## **PUBLIC SERVICE COMMISSION OF WISCONSIN**

PSC Docket No. 05-CE-136

### **NO CAPX 2020 RESPONSE TO NOTICE OF POSSIBLE RECESSION OF ORDER GRANTING PARTY STATUS AND ORDER TO RESPOND**

## **NoCapX2020 DEIS Comments**

**Figure 3-3  
Hampton–Rochester–La Crosse 345 kV Project, Proposed Configuration**

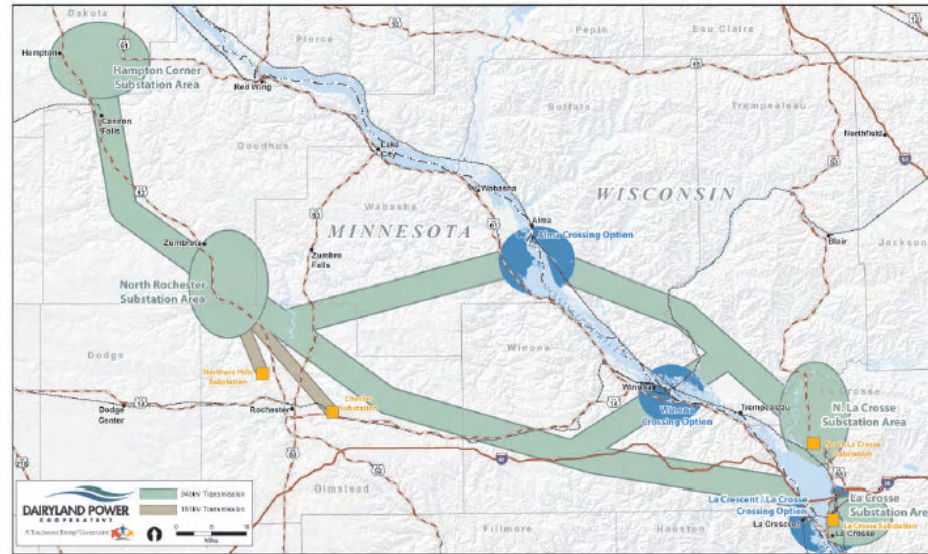
| 01-20 | RUS                  | The Minnesota Certificate of Need application proposed four Mississippi River crossings, at Alma, Winona, Trempealeau, and LaCrescent (PUC Docket 06-1115, Application p. 1.2). The Minnesota Transmission Routing application for the Capx 2020 Hampton-Rochester-LaCrosse transmission project proposed only one Mississippi River crossing, at Alma (PUC Docket 09-1448). Likewise, the Wisconsin CPCN application for CapX 2020 Hampton-Rochester-LaCrosse proposes only one Mississippi River crossing, at Alma (PSC 05-CE-136, Application, Figure 8, Map). Identify the number and locations of Mississippi River crossings proposed for review in the Dairyland application/request to RUS, in the AES (Figure 3.3 below) and MCS of May 2009, and the Mississippi River crossings proposed in any subsequent filings with RUS. If the Mississippi River crossings in the WI PSC CPCN application, one crossing proposed at Alma, are different from those in the Dairyland application/request to RUS, in the AES and MCS, explain the differences. For example, reference the AES Figure 3.3 below: |
